Inver Grove Heights Planning Commission
Tuesday, May 2, 2023 at 7:00 PM
8150 Barbara Avenue, Inver Grove Heights, MN 55077

AGENDA

Planning Commission Report

Planning Commission Report

Figure 1 Photograph of possible wet soil provided by Planning Commission

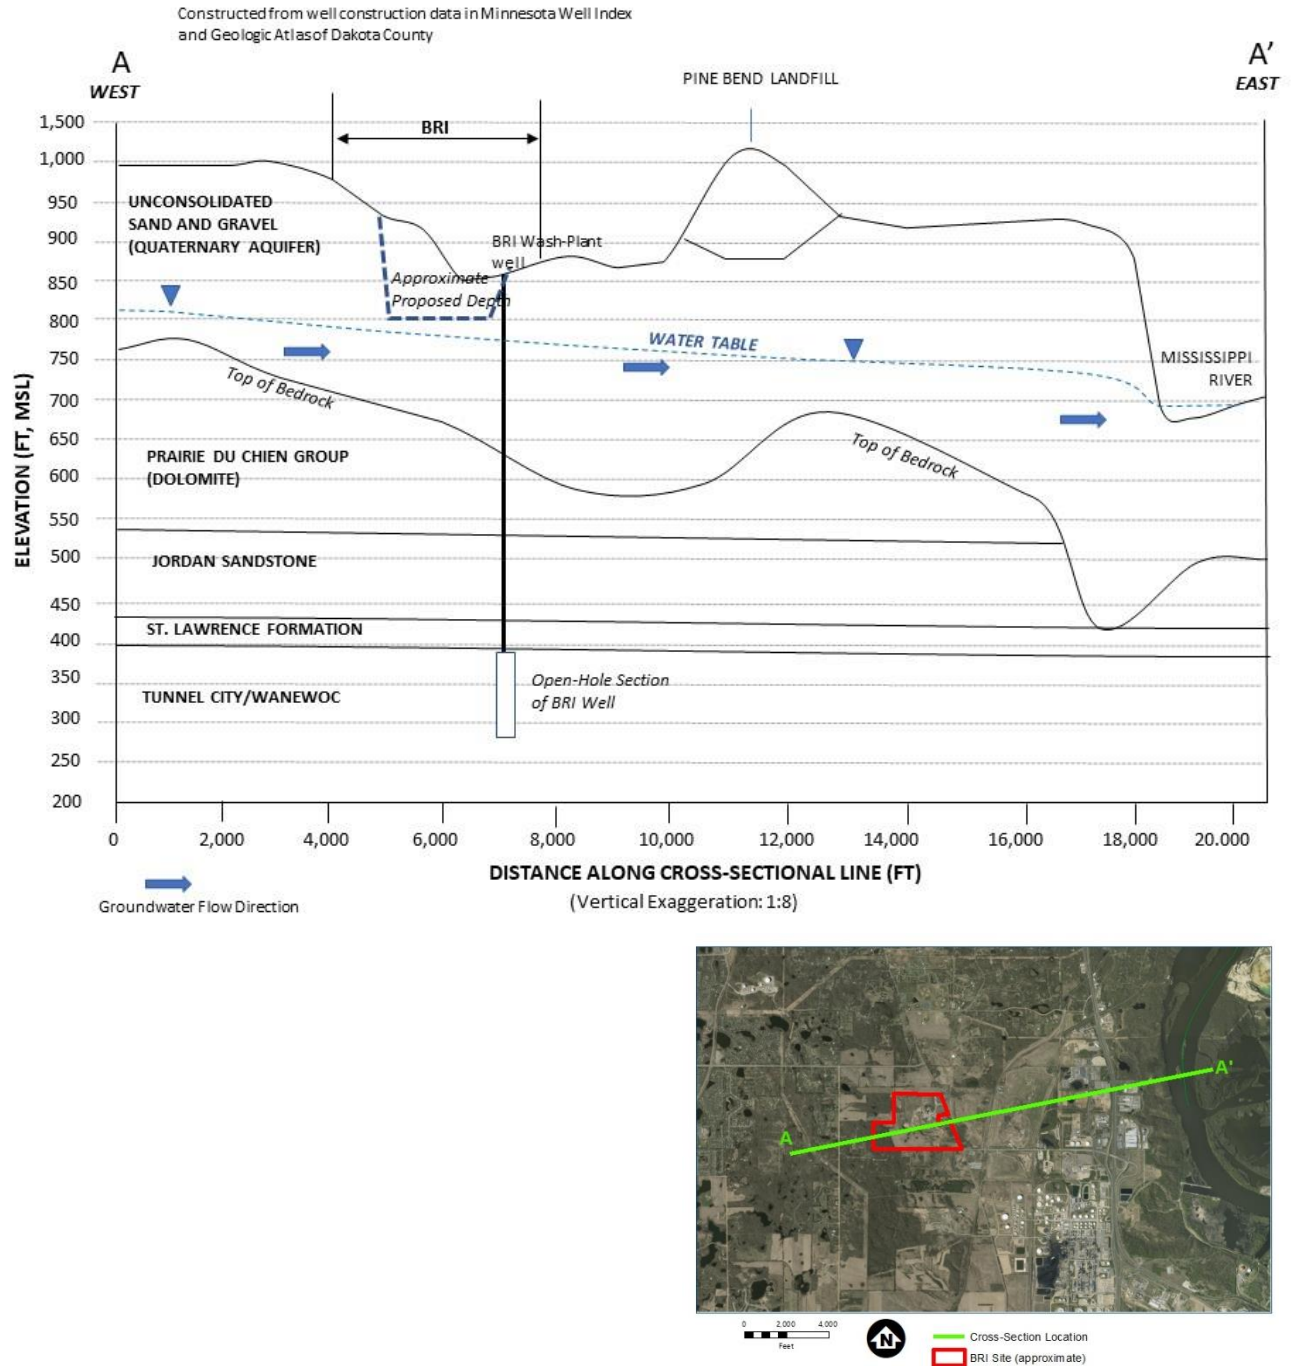
840 feet and the proposed depth of mining is approximately 800 feet. The darker soils shown on Figure 1 may be due to higher moisture in the soil but darker soils could also be due to other factors. However, the darker soil in the photograph provided by the Planning Commission is at least 40 feet above the water table. Dark and/or moist soil conditions can be caused by many different activities and conditions that have nothing to do with the water table. Given that there is 40-plus feet of separation between the water table and the elevation of the soil shown in the photograph, we can say with certainty that the darker soils are not due to intersection or close proximity to the top of the water table.

Figure 2 West-to-East Geologic Cross Section Along Groundwater Flow Path Through BRI Facility

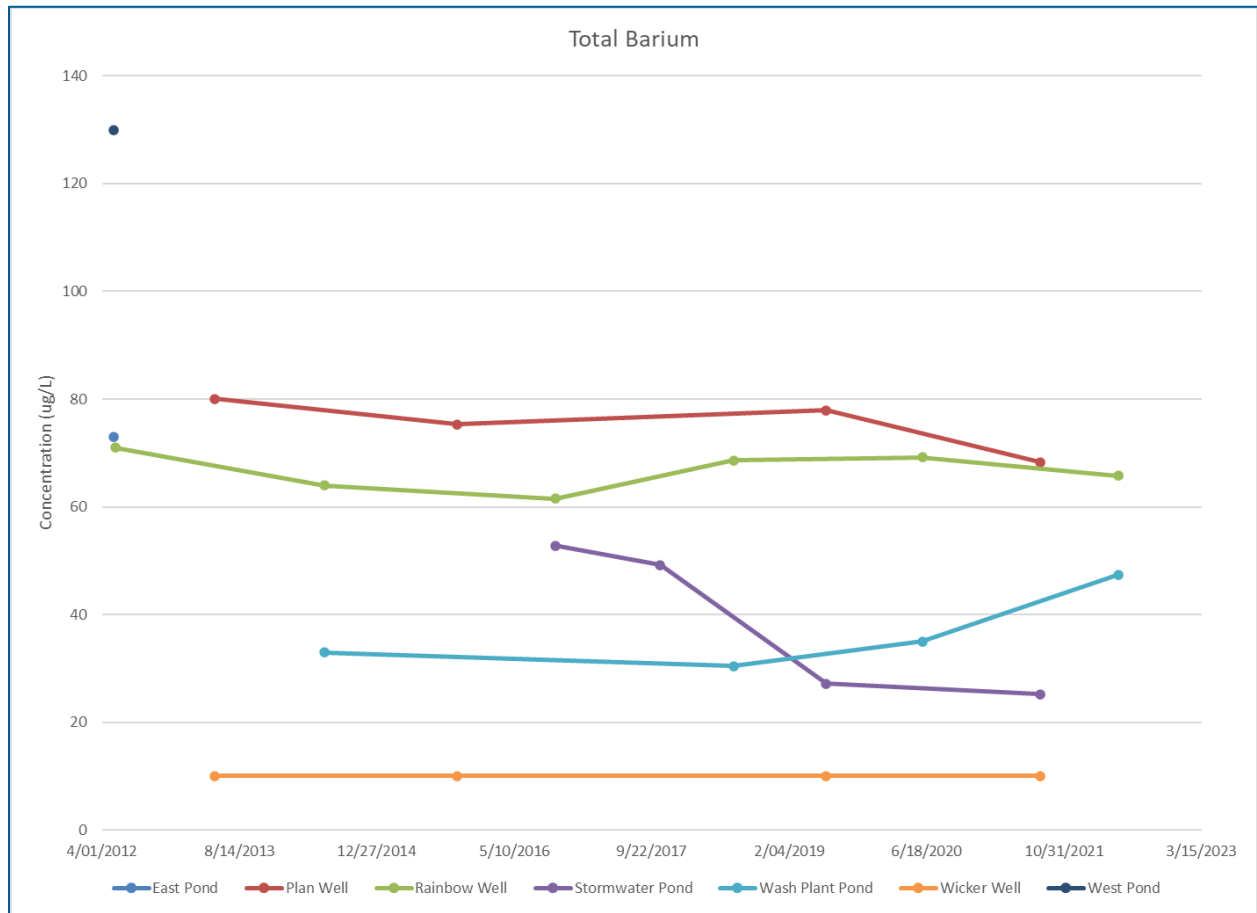
The location of the foundry sand stockpile is located on the east-central portion of the BRI site. The image referenced in the Question #1 is provided as Figure 1 of this memorandum. A cross-sectional view of the current and proposed expanded mine depth in relation to the water table, and the top of the Prairie du Chien-Jordan aquifer and top of the Tunnel City-Wonewoc aquifer is shown on Figure 2.

Figure 7 Model Simulation of Steady-State Drawdown (feet) in the Tunnel City-Wonewoc Aquifer Resulting from Pumping of BRI Wash-Plant Well at Average Pumping Rates

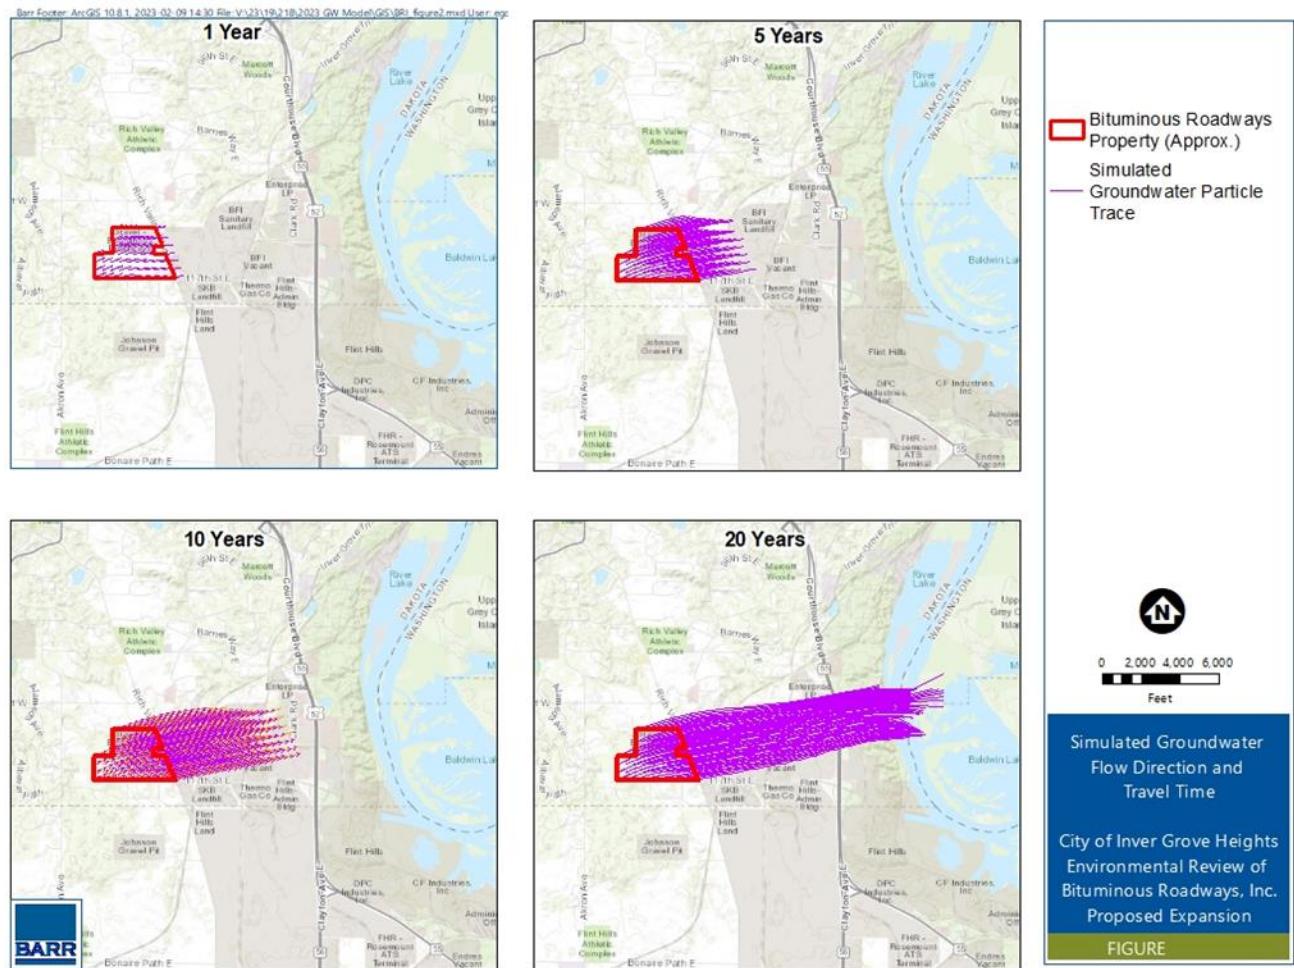
Contours of the predicted drawdown in the Tunnel City-Wonewoc aquifer that result from pumping the BRI wash-plant well are shown on Figure 7. The drawdown (i.e., the lowering of the potentiometric surface) in the Tunnel City-Wonewoc aquifer is predicted to be less than about 2 to 4 feet beyond the boundaries of the BRI facility. The nearest water-supply well completed in the Tunnel City-Wonewoc aquifer is located within the Flint Hills Refinery and is predicted to experience a drawdown of less than 0.5 feet due to pumping of the BRI wash-plant well and would not experience any measurable reduction in well yield, given the several hundred feet of available drawdown in the Flint Hills Tunnel City-Wonewoc well.
